**Title:** Final Agency Decision Statement

**Project Name:** McGraw Trucking Site/C3-019-72493

**Responsiveness  
Summary:**

**Figure 1**  
Site Location Map  
McGraw Trucking  
Frontenac, KS

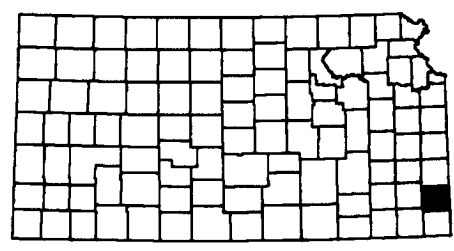
Comment #8: **Page 5, Figure 1:** *This figure depicts the Site in the wrong location.*

Response #8: The figure has been updated.
